Land North West of Southwater

LLFA Response

To: Eleanor Read - WSCC
From: Darren Brown
Cc: Aaron Wadhams/ Simon Purcell
Ref: TN-LLFA-001
Date: 2026-05-18
Subject: DC/26/0366 – Land North West of Southwater

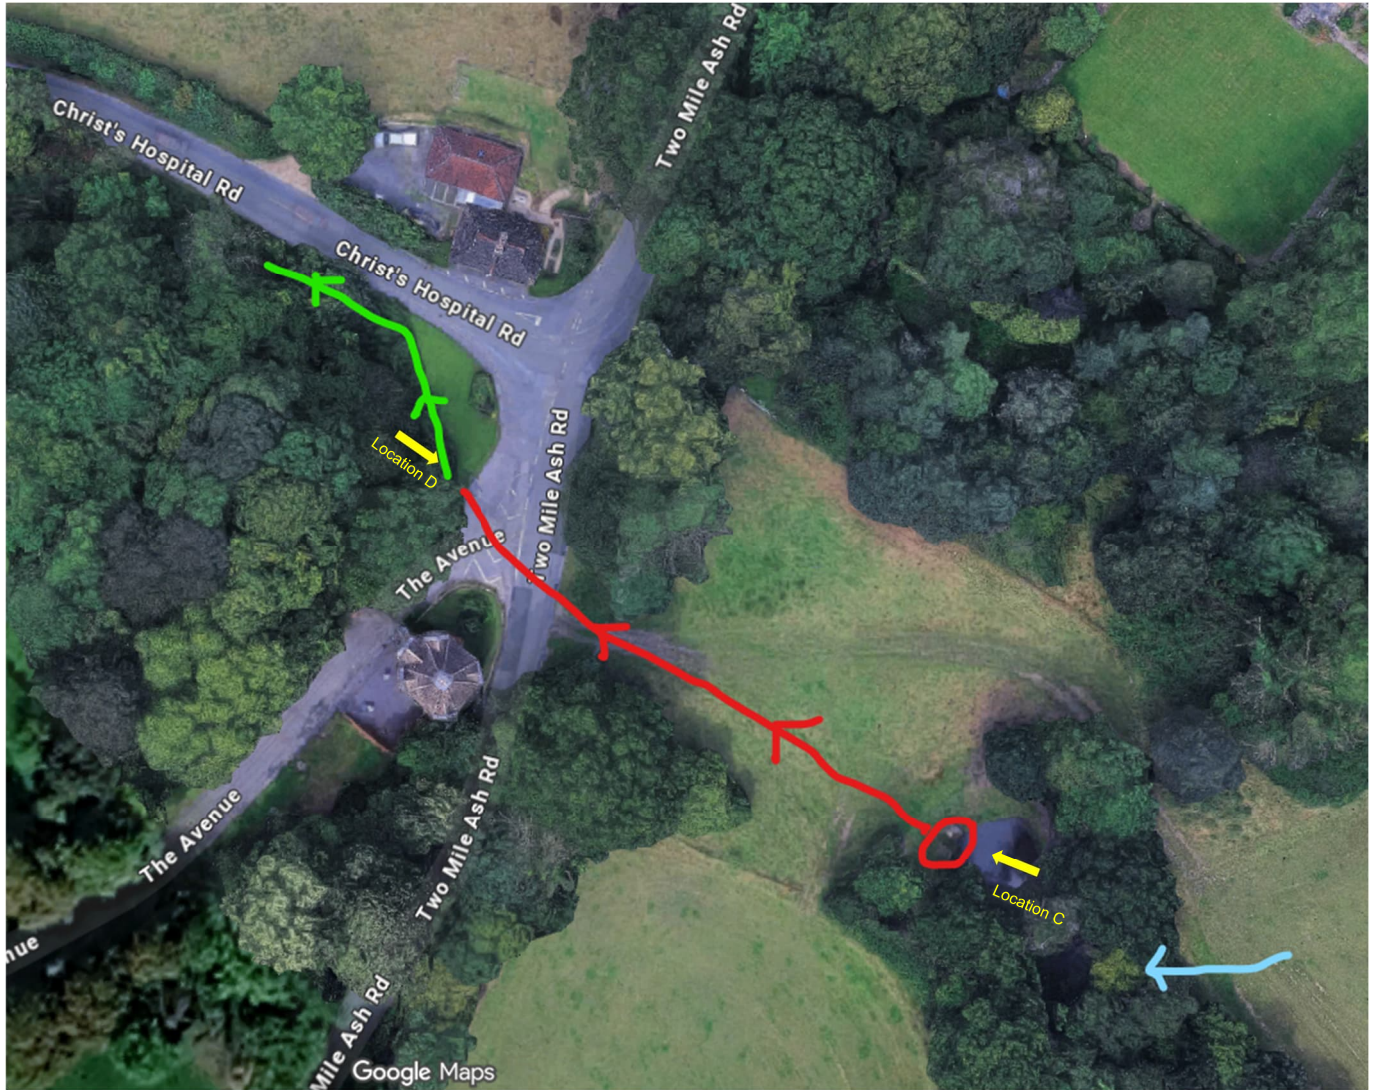
It is unclear where the swale for Basin 4 will discharge to, as the watercourse is not on the drawing.

Similarly, it appears that Basin 2 is proposed to discharge into a ditch that, based on the topographical survey, does not have onward connectivity, as there is a label “ditch fades in this area”. Based on the information submitted it is assumed that the watercourse is culverted from the location of the ‘pond’, under Two Mile Ash Road, then the watercourse reopens within the grounds of Christs Hospital School. The details of this culvert (route, capacity and condition) and onwards connectivity of the watercourse are unknown currently and as such further investigation is required. This is to ensure that this watercourse is able to receive flows without increasing flood risk elsewhere. If it is found that the watercourse cannot receive these flows, alternatives will need to be explored at outline stage, to ensure there is a viable method of draining the north catchment. This is not something we can condition for reserved matters/detailed design stage, as if it is found that the watercourse does not have onward

connectivity, this is likely to require alterations to the parameter plan. For avoidance of doubt, the onward connectivity of all watercourses that it is proposed to discharge surface water at restricted rates to, must be demonstrated at outline stage.

Basin 2

Following the investigation connectivity of the Basin 2 outfall could not be located and is believed to have been culverted/filled historically to provide agricultural access. As such the proposed outfall has been relocated to discharge directly to the ordinary watercourse/pond, see updated strategy drawing appended to this note.

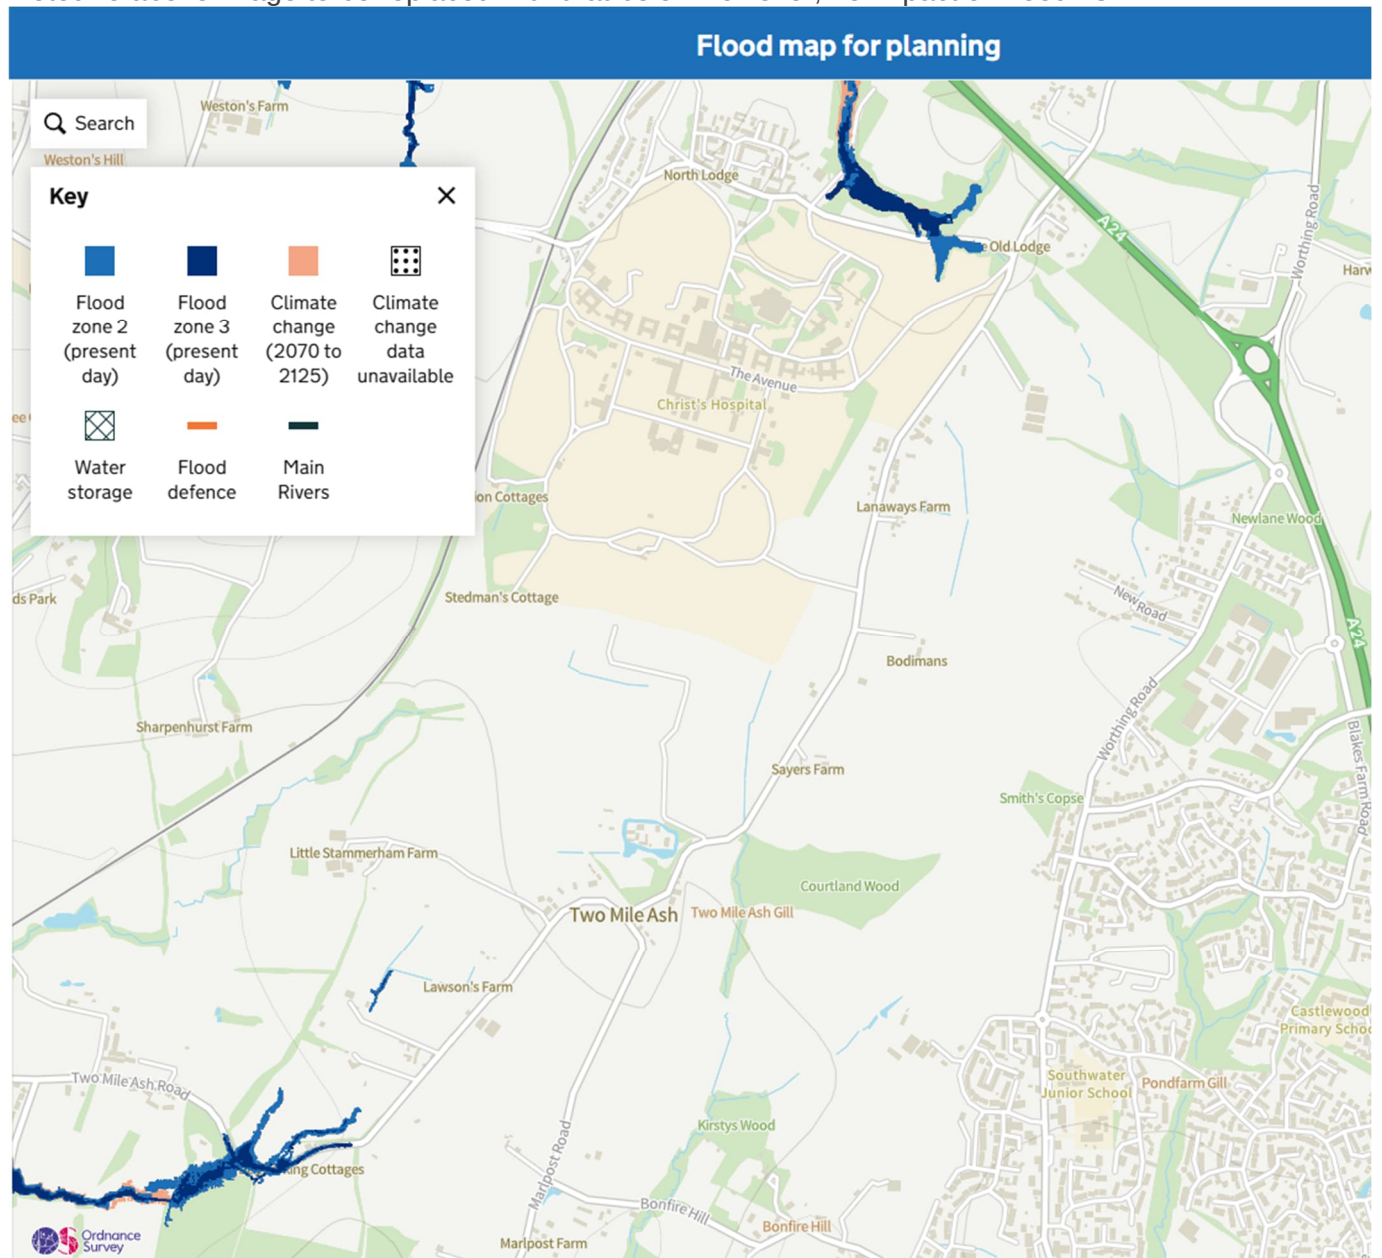
As stated in pre-app, a C_v value of 1 shall be used in calculations. Whilst we cannot check the outputs for Annex D adequately currently (see Point 8/9), paragraph 8.3.4 states that C_v values are set at 0.75 and 0.84 instead.

We would expect the total volume in the hydraulic calculations to correspond with the drainage layout. For example, for Basin 3, the drainage layout says the storage volume will be 425m^3 , whereas the calculations say 427.176m^3 . It is important these match.

This means that we currently cannot check the post development greenfield runoff rates and volumes properly in Annex D.

In the hydraulic calculations, there seems to be no outputs demonstrating the correct impermeable area has been used. In addition, we are currently unable to check the input parameters for the calculations, as this is not provided within the current outputs. We typically see quick storage estimates for an outline application.

C_v values of 0.75 and 0.84 have been used for the calculations. While we understand that the reasoning for use of a C_v of 1 is primarily a precautionary and risk-based assumption rather than a physically representative parameter. Its indiscriminate use can lead to inefficiencies and misalignment with SuDS objectives and it is not deemed appropriate for this site. A C_v value of 1 would fail to reflect the SuDS based approach to the Surface water strategy for the site and would over provide for the surface water network by over sizing pies and storage, increasing cost and embodied carbon. The SuDS example included with in the FRA gives indication how the proposed development would achieve the interception of the first 5mm of rainfall for all storms in line with national SuDS guidance. However, as a sensitivity test, we have assessed the impact of adopting a C_v value of 1. This would result in an increase in the

size of the ponds as shown on the plan appended. This shows that the ponds can be accommodated within the areas of open space without impacting on the net developable areas or play space. The storage volumes have been rounded from the Infodrainage results and will need to be finalised. Updated calculations and quick storage estimates have also been appended to this note. Full details of the and design of the drainage systems will be developed further at reserved matters stage.

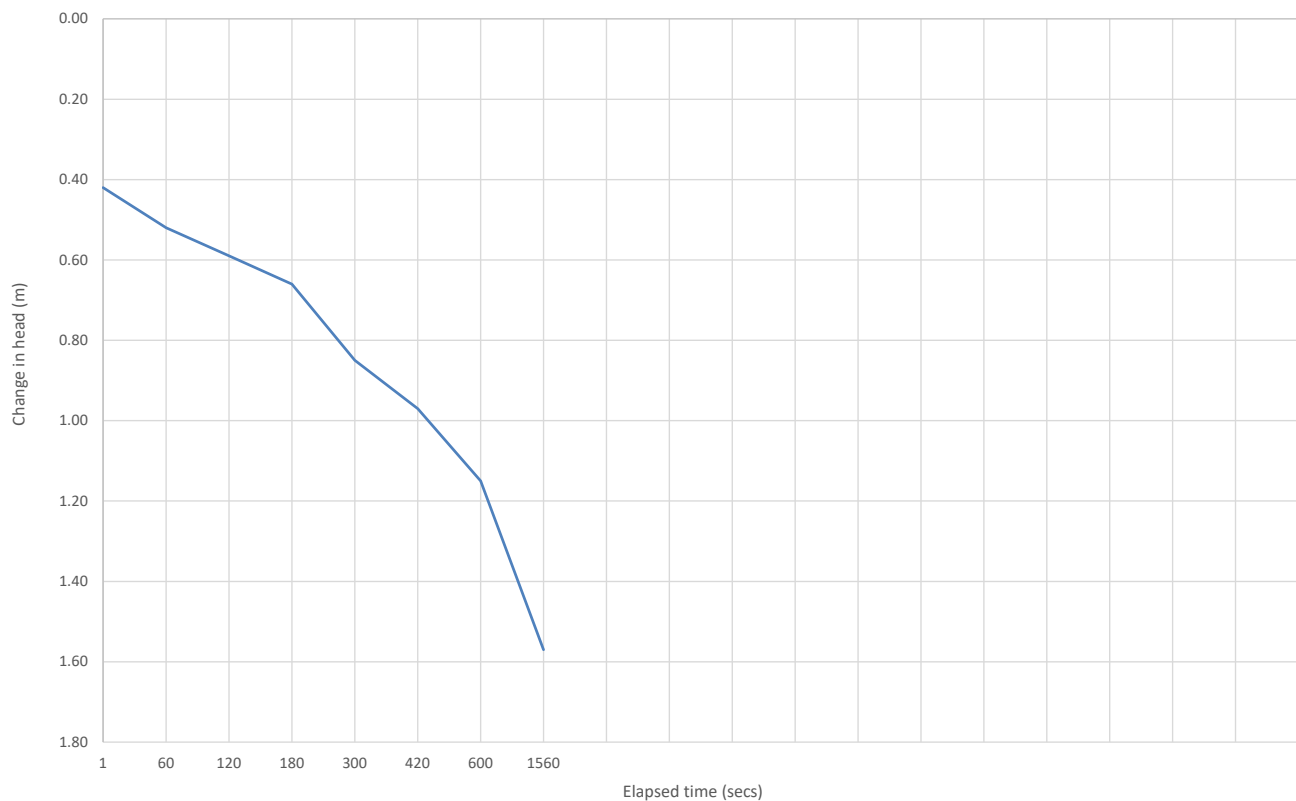
While the proforma says in Section 7 that infiltration tests have been completed, these have not been provided.

Site investigation was undertaken by GESL 5 infiltration tests were carried out across the Site, with two tests being unable to produce an infiltration rate due to the lack in fall in head. The remaining tests gave results between 2.47x10⁻⁸m/s and 8.61x10⁻⁸m/s, confirming the “slowly permeable” nature of the soils. A copy of the GESL report has been appended to this response. Further infiltration testing should be undertaken at reserved matters stage for each phase as the site progresses.
